CITY OF WEST SACRAMENTO

DESIGN REVIEW ADMINISTRATOR ACTION FORM

Request: Design review approval of a ±292-unit multifamily apartment project on a 11.4-acre project site in the Mixed-Use Neighborhood Commercial (MU-NC) zone. The project has a main five story apartment building fronting Jefferson Boulevard, two story buildings surrounding the project site along the eastern and southeastern edge of the site along the Clarksburg Branch Line Trail, and three story apartment buildings in the center of the property that surround a leasing office/recreational building and swimming pool.

JEFFERSON VILLAGE APARTMENTS DESIGN REVIEW CONDITIONS OF APPROVAL

SHEET TITLE
SITE PLAN
FIRE COVERAGE

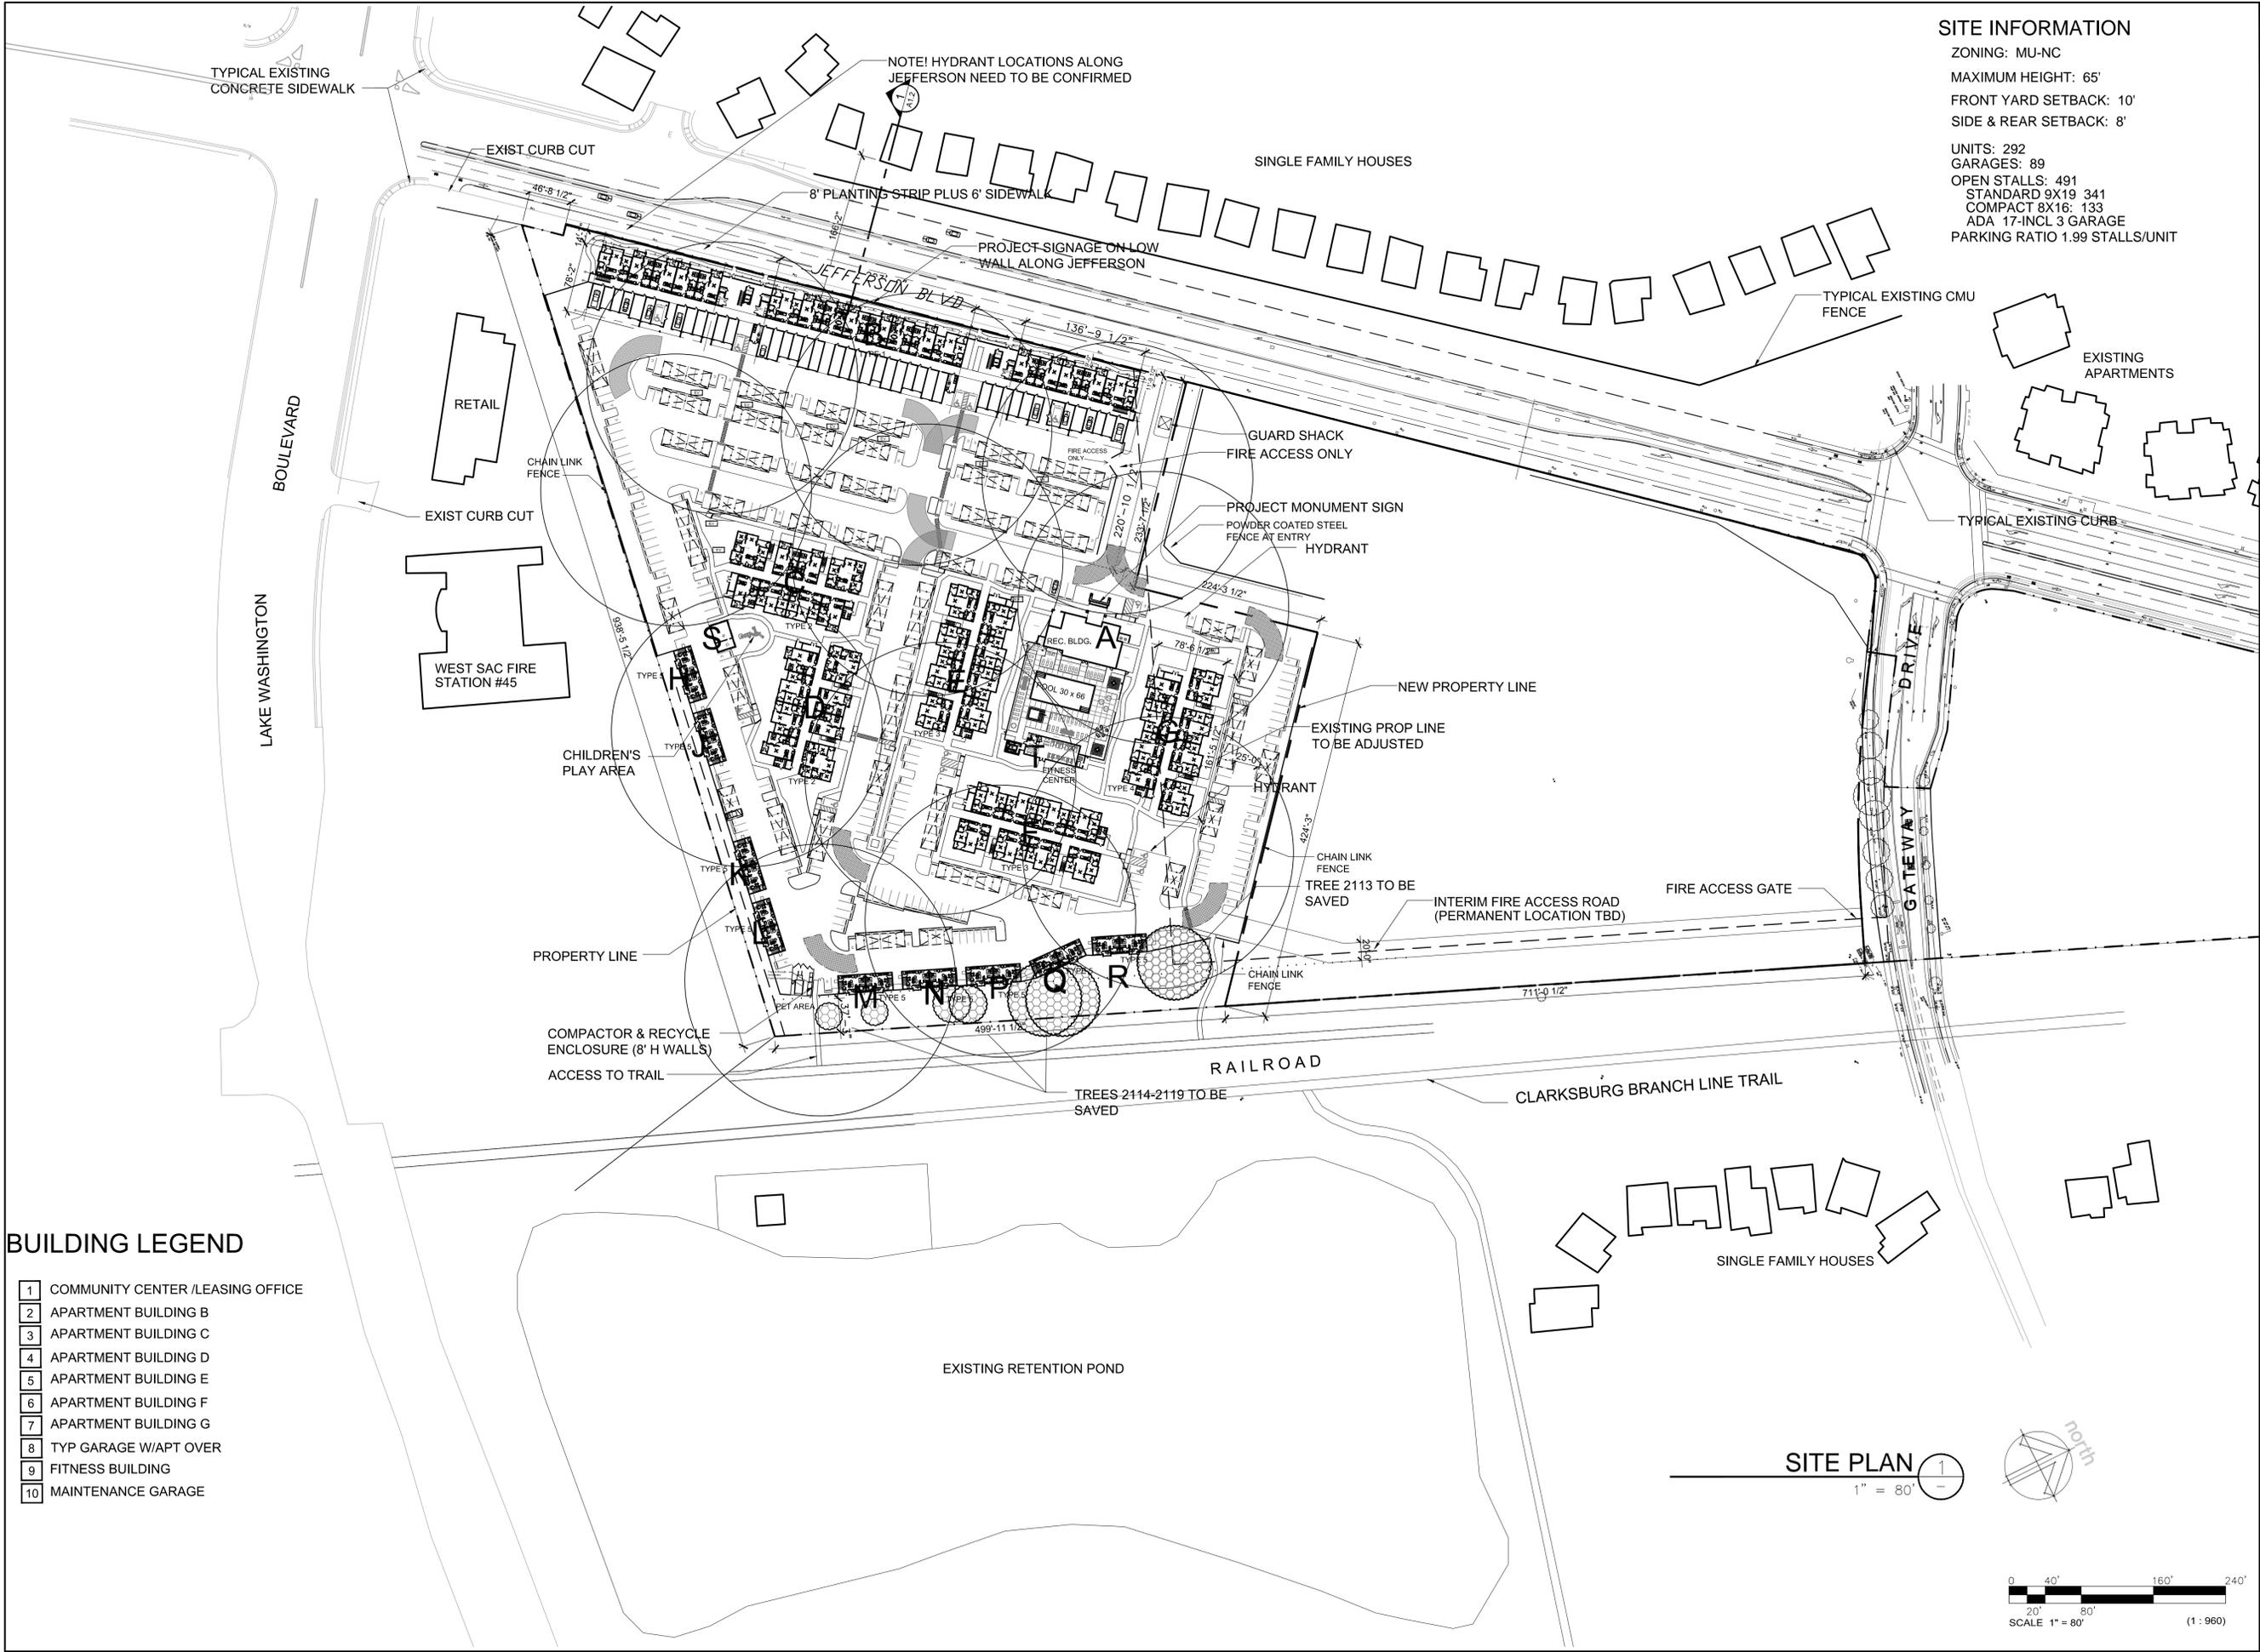
1. The chain link fencing shown on the provided site plan shall be replaced with an alternative fence material such as decorative wrought iron or brushed metal and shall be in a location not interfering with any City easements or Reclamation District 900 easements that restrict their ability to access their drainage canal. Chain link fencing is prohibited by the Southport Framework Plan.

2. To meet bike/pedestrian connectivity requirements the developer shall connect the pedestrian and bike access trail, identified on the eastern side of the site plan, from the property line to the Clarksburg Branch Line Trail. The new connecting trails shall be constructed of an impervious material.

9. No vehicular gates shall be constructed at project ingress/egress points on Jefferson Boulevard and Gateway Drive pursuant to Policy 6.9 of the Southport Design Guidelines.

13. Project access onto Jefferson Boulevard shall be in a right-in/right-out only configuration as this design review approval does not include a traffic signal on Jefferson Boulevard. Consideration of a traffic signal on an arterial roadway requires a separate application to the Capital Projects and Transportation Department for consideration by the City Council.

14. An acceleration and deceleration lane on Jefferson Boulevard shall be provided at the project entrance off Jefferson Boulevard. This may necessitate moving the project entrance driveway towards Gateway Drive as required by the City Engineer. The acceleration and deacceleration lanes shall meet the minimum lengths required for the road type and volume as determined by the City Engineer and City Traffic Engineer.

15. A full secondary vehicular access point onto Gateway Drive shall be provided per City Standard Specifications and the Southport Framework Plan.
16. The drive aisle which parallels the eastern property line north to south shall be constructed in such a manner that a future extension to the south of the project is not precluded.

17. The project entrance along Jefferson Boulevard shall have strong thematic entry landscaping and a drop-off zone to comply with Policy 6.5 and 6.13 of the Southport Design Guidelines. Additionally, the guard shack should have a slanted roof and low-level accent lighting.

1. Site access onto Gateway Drive (a residential collector street) shall be located as close as possible to the Clarksburg Branch Line Trail and shall be signalized for the safety of pedestrians and cyclists at the trail crossing.
